**HVAC Submittal 230500-06**

**Job Name/Number:** Bethany Elementary School – Job #2302002

**PROJECT:** BETHANY ELEMENTARY SCHOOL– KITCHEN  
ADDITION  
CLOVER, SC

MARK: EF-2 DW

# RCG

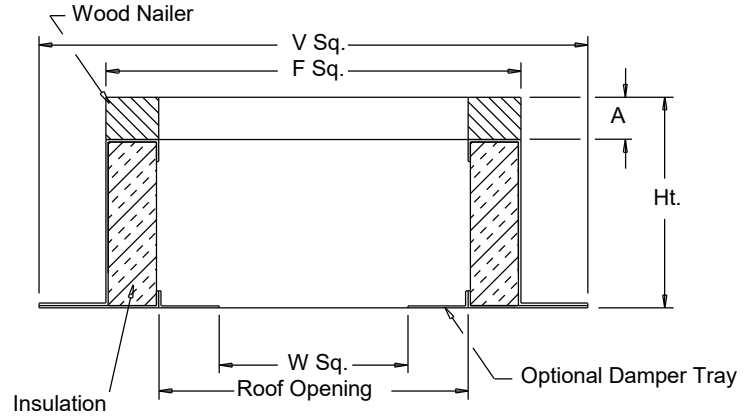
- 1. Dishwasher Fan by Cook: No Exception As Corrected**
  - An adapter roof curb is required to sit on the old RTU curb.**
